ADDENDUM NO.2

**CHICAGO O'HARE INTERNATIONAL AIRPORT
TERMINAL 5 CONCOURSE M EXTENSION SITE/CIVIL PACKAGE
SPECIFICATION NO. 766477**

ES-205	1
--------	---

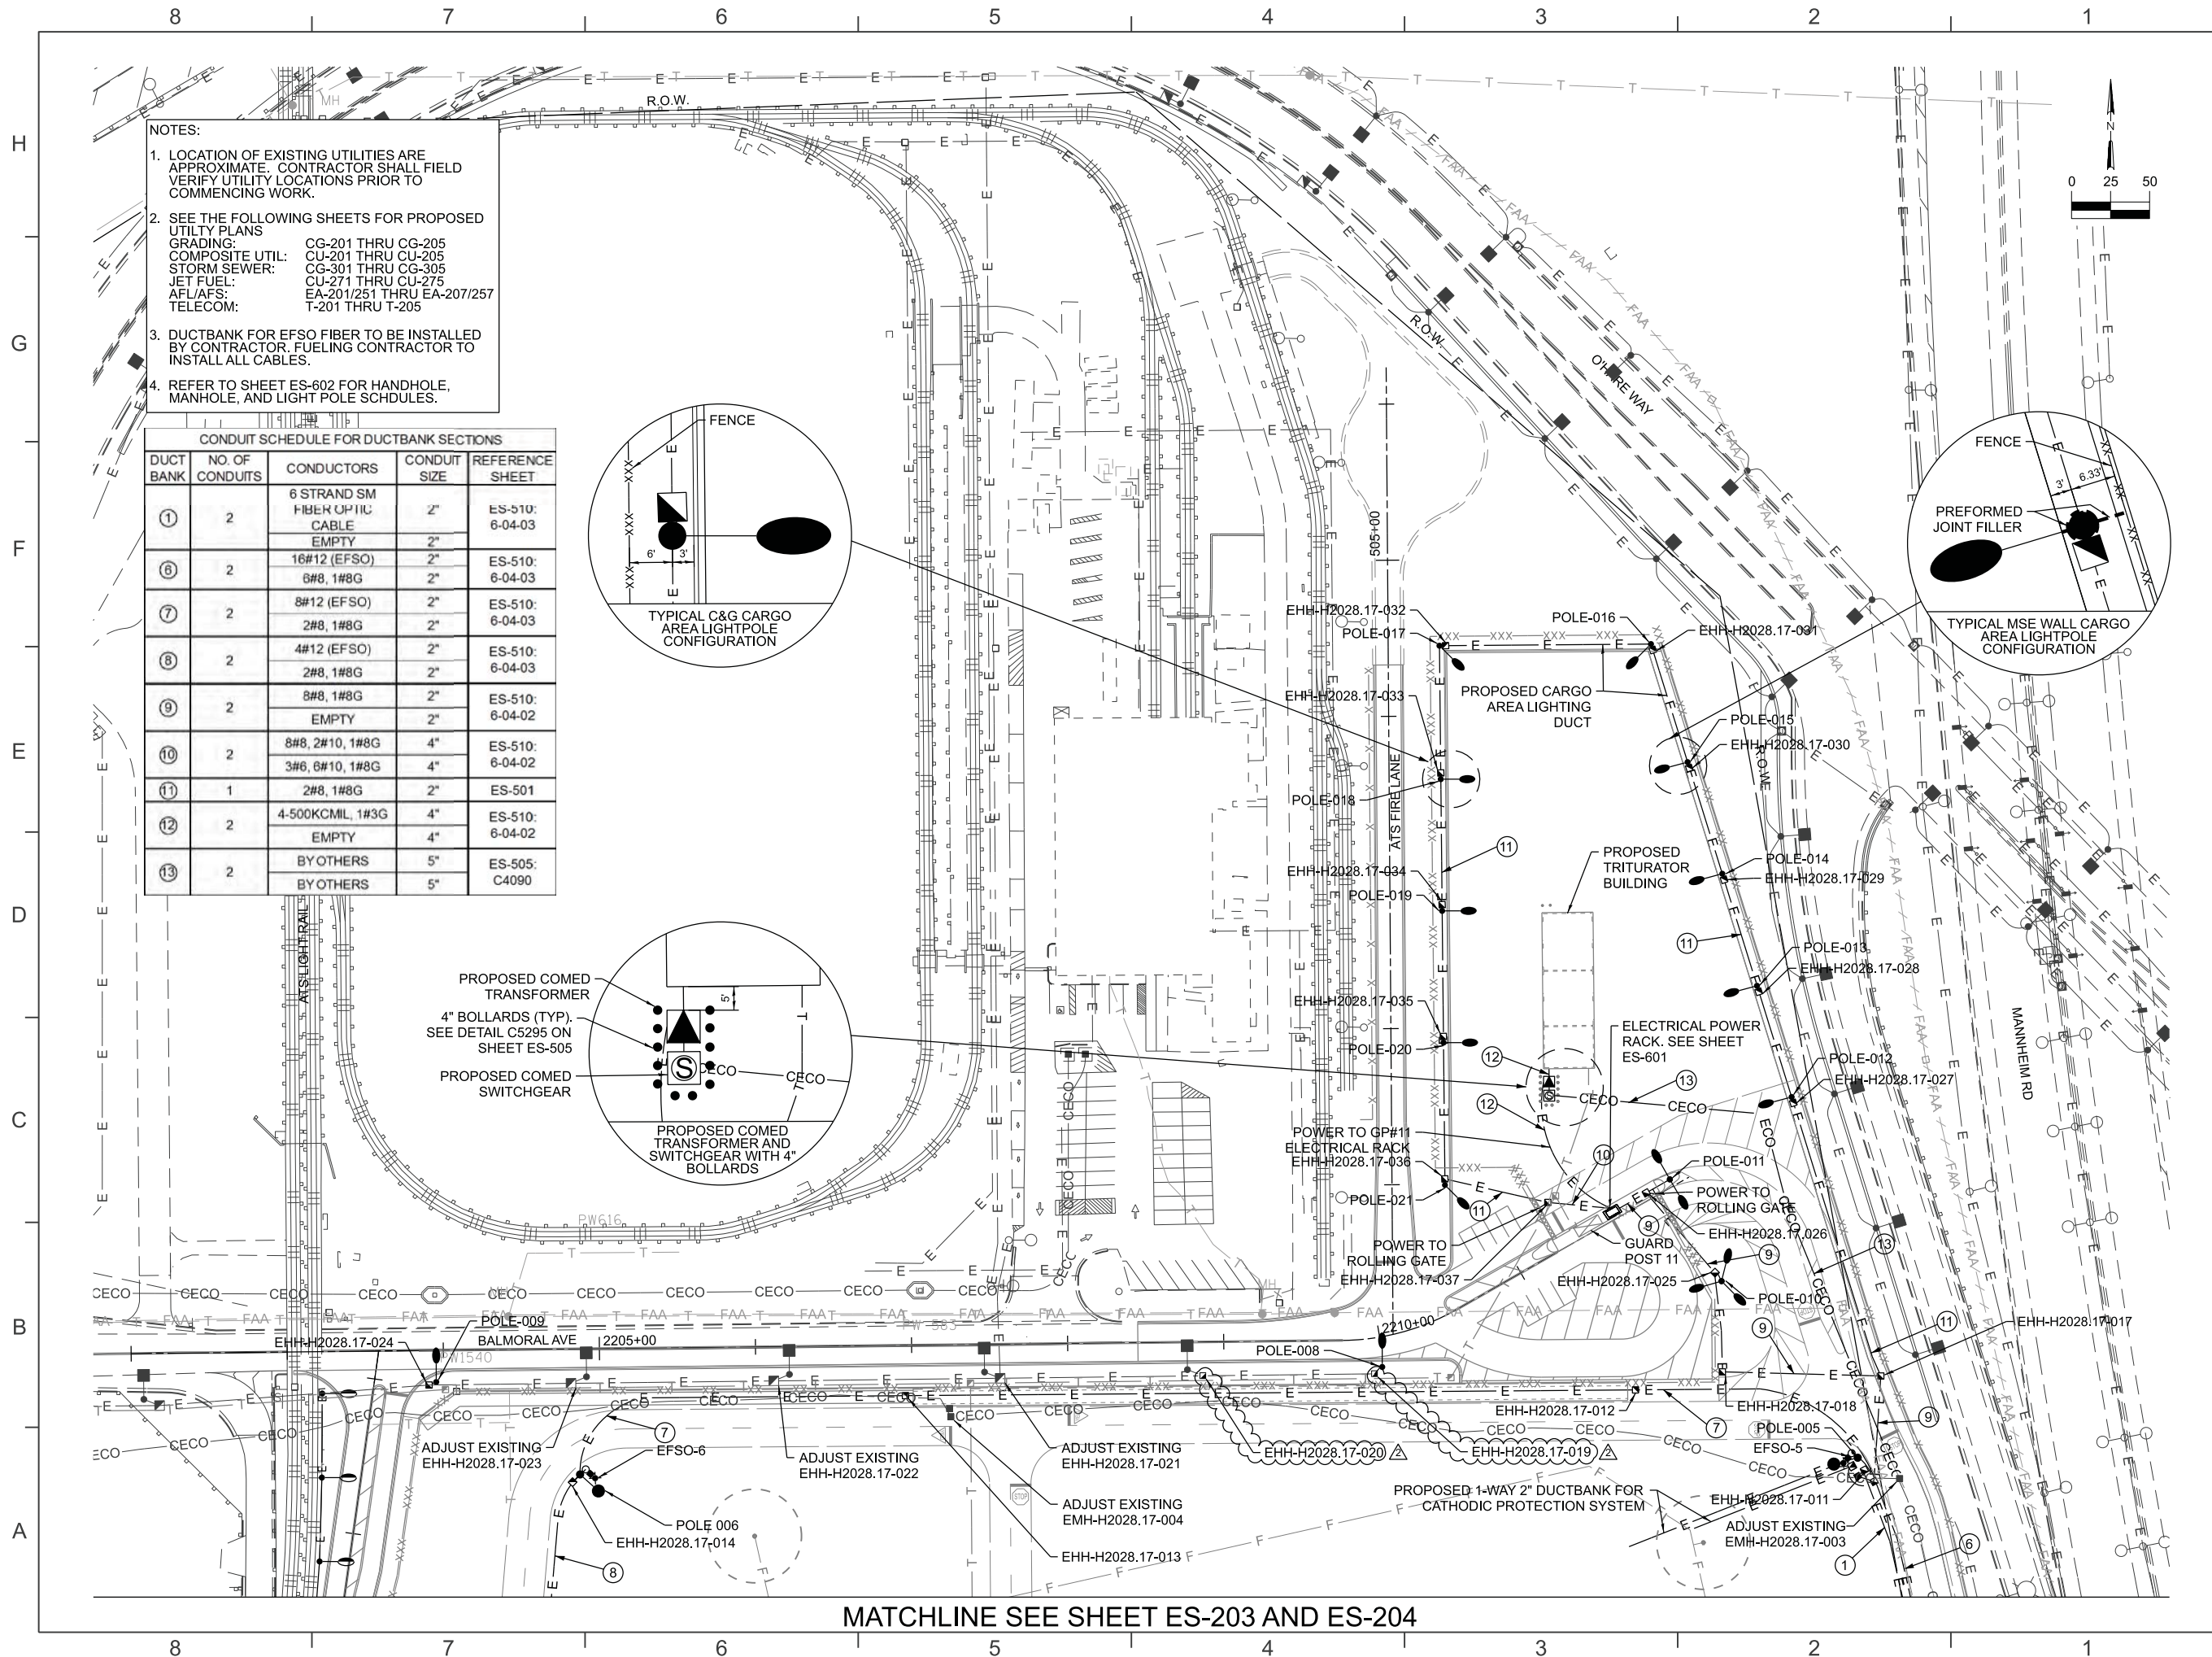
ES-204	Modified EHH-H2028.17-0190 and EHH-H2028.17-020 from reconstructed handholes to new handholes.
ES-205	Modified EHH-H2028.17-0190 and EHH-H2028.17-020 from reconstructed handholes to new handholes.
ES-502	Modified Pole-Mounted EFSO Station and Conduit Penetration Thru Terminal Building Exterior Wall Details to clarify delineation of work limits between Contractor and Fueling Contractor.
ES-503	Modified the Isolation Valve Pit for ISO-6 Detail to clarify delineation of work limits between Contractor and Fueling Contractor.
ES-602	Modified Electrical Handhole Schedule for EHH-H2028.17-0190 and EHH-H2028.17-020 to reflect change from reconstruction to new installation. Corrected the reference sheet detail for EHH-H2028.17-024.
A-102	Added note to clarify hierarchy between plan sheet and specification discrepancies for the prefabricated guard booth.
T-201	Modified call out to indicate required innerduct.

Response:	<i>All existing foundations will stay where they are. Drawing Sheets ED-103, ED-104, and ED-105 have been updated.</i>
Question 18:	Sheet ES-204 and the Handhole Schedule on Sheet ES-602 show reconstruction of (2) roadway handholes EHH H2028.17-019 and -020. Please provide details for this work. Also, how is this work paid?

Response:	<i>Roadway Handholes EHH H2028.17-019 and -020 have been changed to being demolished and replaced. Drawings Sheets ED-104, ED-105, ES-204, ES-205, and ES-602 have been updated.</i>

SHEET NO.	REVISION
T-204	1

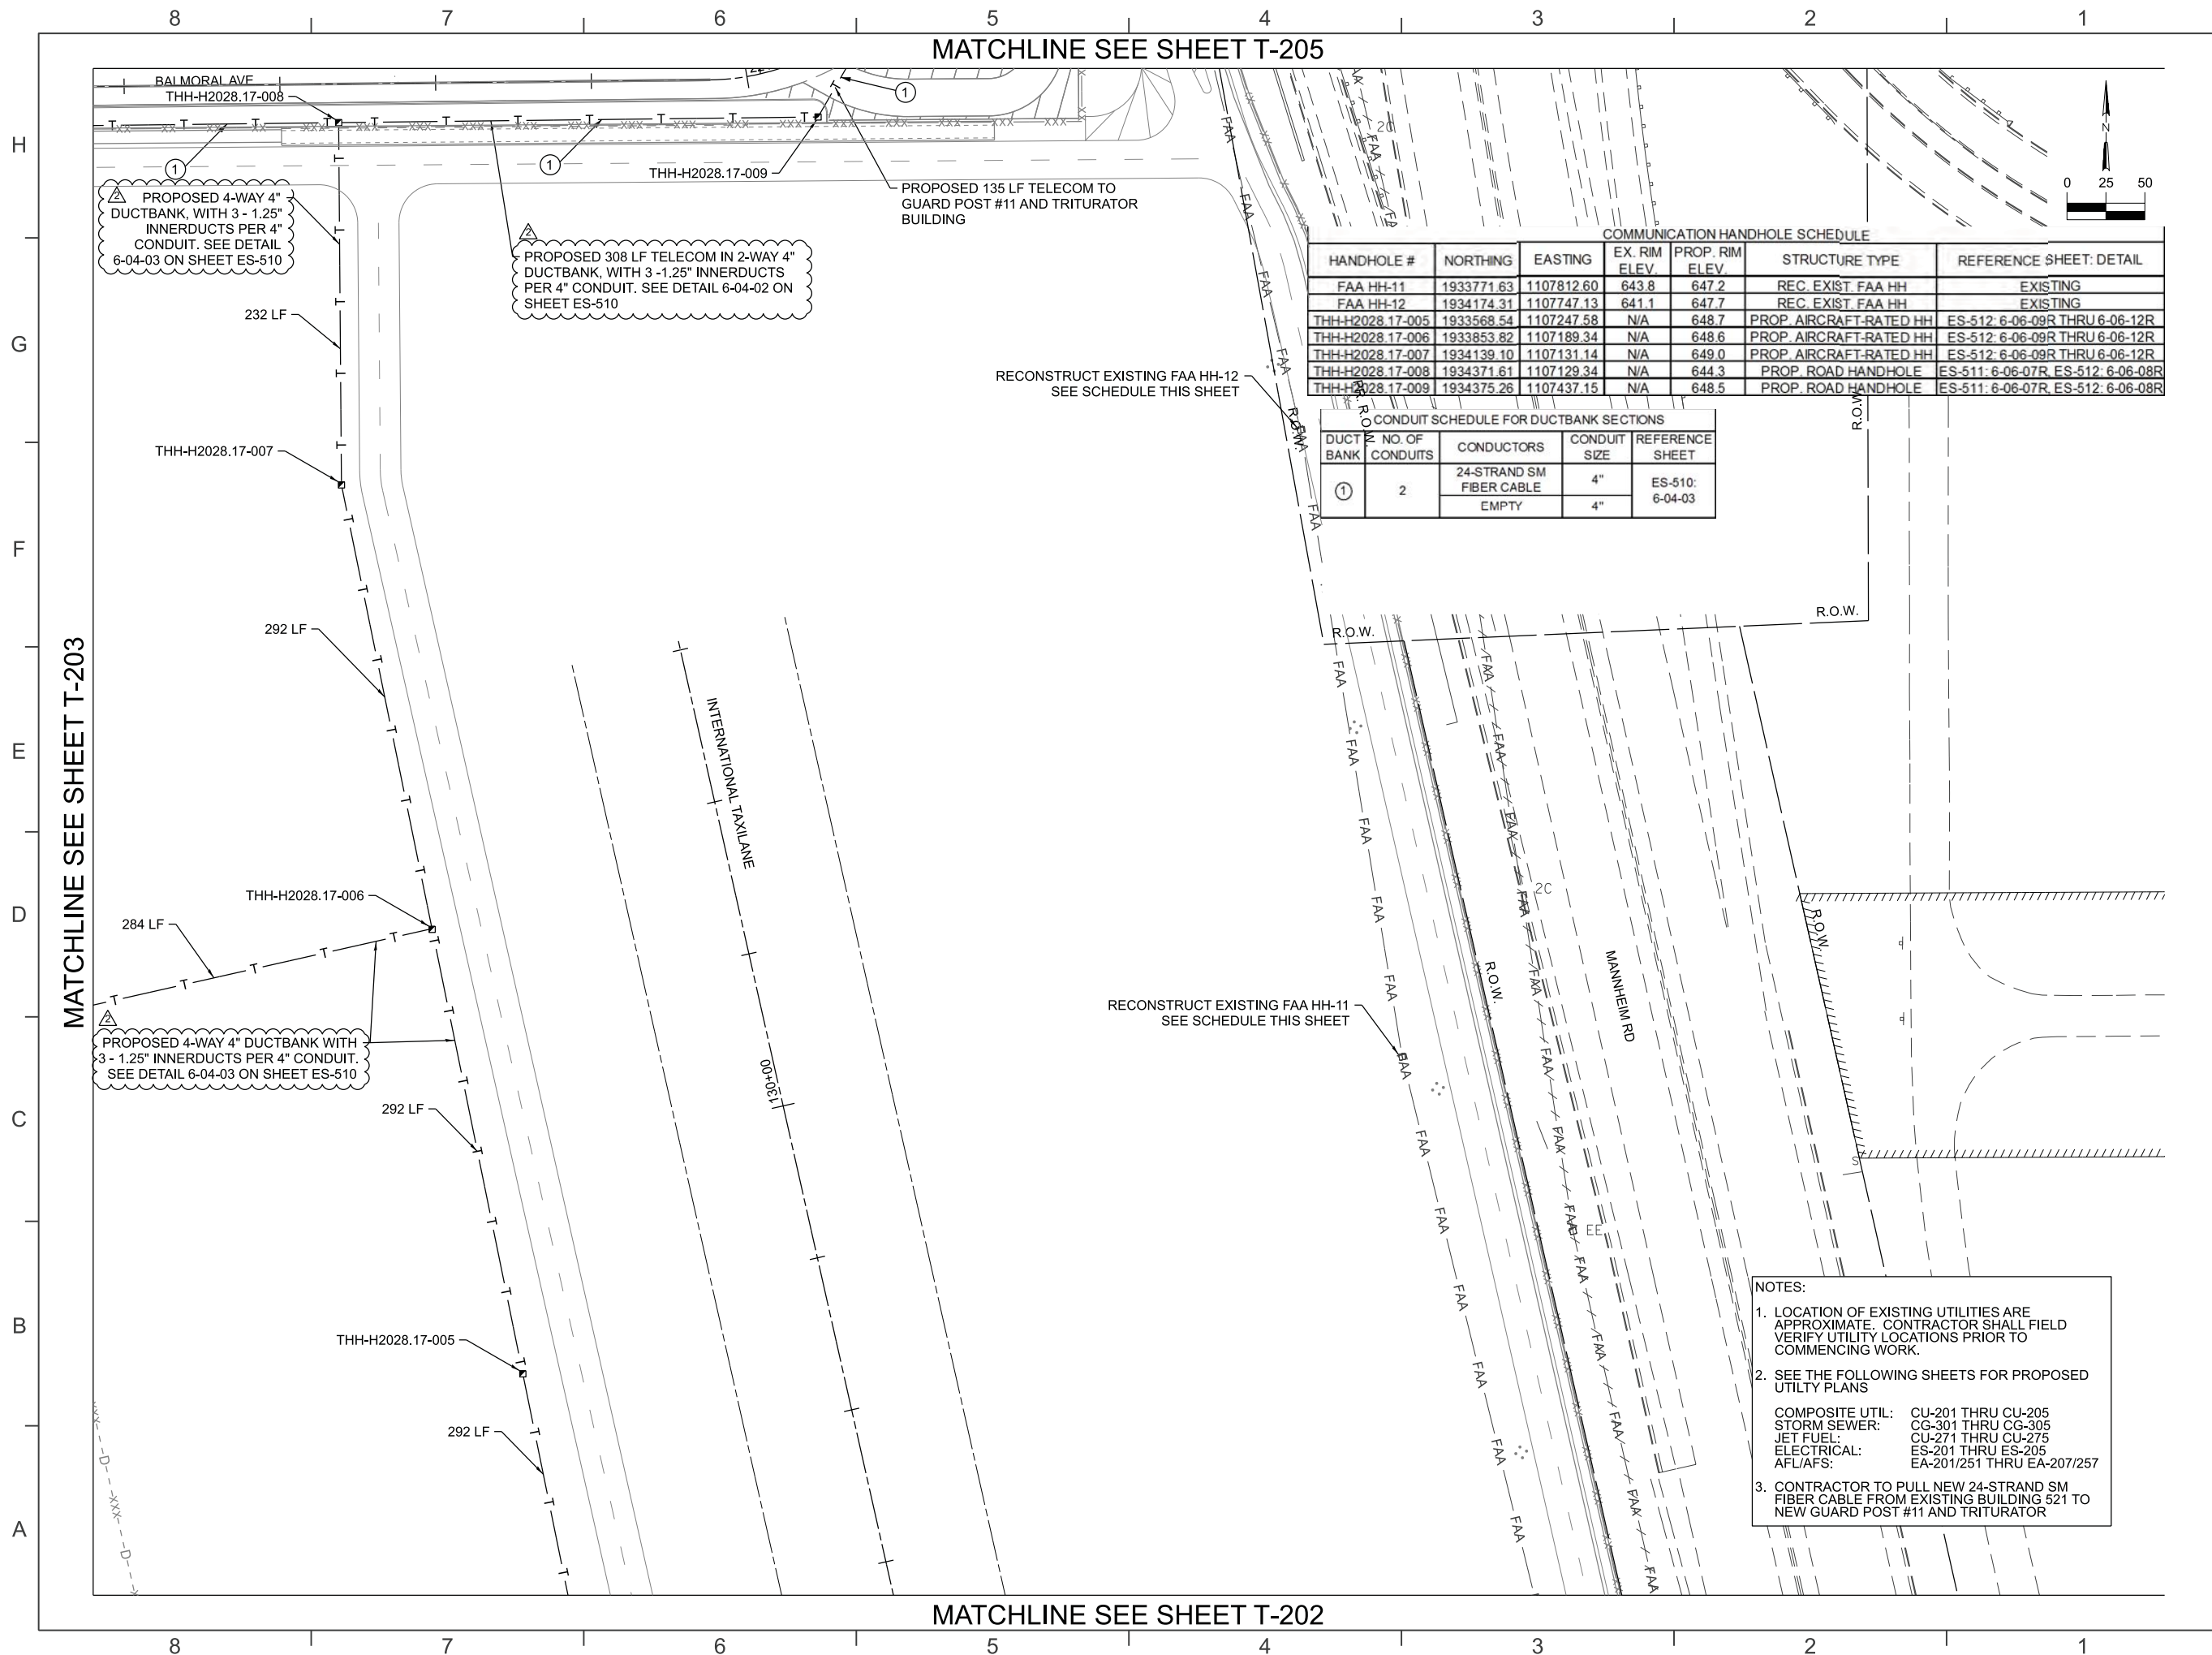
T-202	Modified call out to indicate required innerduct.
T-203	Modified call out to indicate required innerduct.
T-204	Modified call out to indicate required innerduct.
T-205	Modified call out to indicate required innerduct.

Response:	<i>Bullet resistance not required, storm resistance is required (wind loading). Use tinted glass.</i>
Question 24:	Item 148, L-110-10 Innerduct, 1.25" - Where is this innerduct installed?

Response:	<i>Three 1.25" innerducts are required to be installed within each 4" PVC conduit in all Telecommunications Duct Bank shown on Drawing Sheets T-201 to T-205. Callouts on Drawing Sheets T-201 through T-205 will be modified to indicate required innerduct.</i>
